UNIVERSITY OF THE PHILIPPINES BAGUIO
Governor Pack Road, 2600 Baguio City

Bid Bulletin No. 1
April 12, 2021

**SUPPLY, DELIVERY, INSTALLATION AND COMMISSIONING OF
ONE (1) UNIT GENERATOR SET**

Bid Reference No. UPB-BID-2021-3

Three (3) Pictures

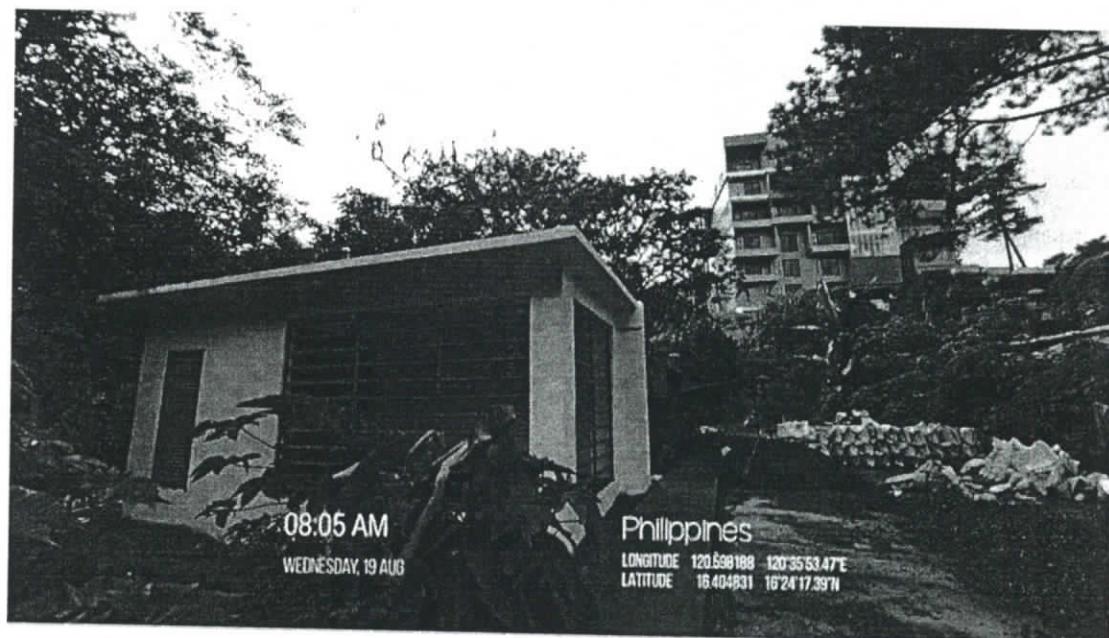
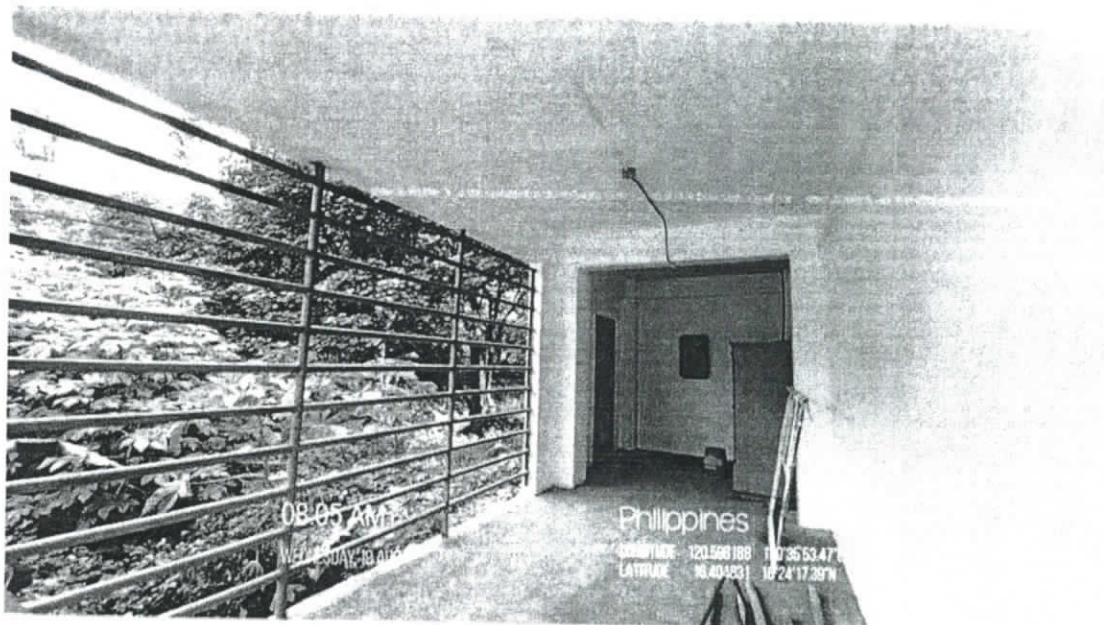
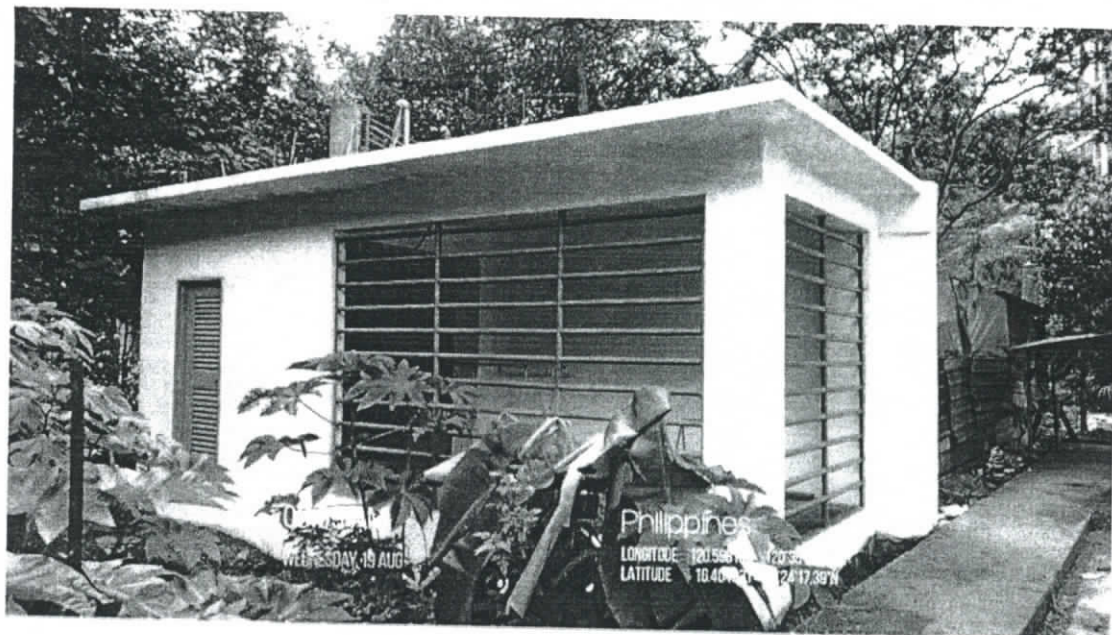
LOCATION	ORIGINAL INSTRUCTIONS	AMENDMENT/ INCLUSION	REASON FOR AMENDMENT
Section III. Instructions to Bidders Clause 5.3	For this purpose, contract similar to the Project shall be: Experience in supply, delivery, installation and commissioning of generator set	For this purpose, contract similar to the Project shall be: Experience in supply, delivery, installation and commissioning of a generator set <u>with at least 100 KVA capacity</u>	To clarify the required definition of similar project
Section VII. Technical Specifications	1500rpm @ 80% Power Factor	1500rpm <u>1800rpm</u> @ 80% Power Factor	To correct the required REVOLUTIONS PER MINUTE
	Lay-out/plans not provided	Lay-out/Plan and picture of the power house is attached to this bid bulletin	To provide general view of the orientation and design of the existing power house
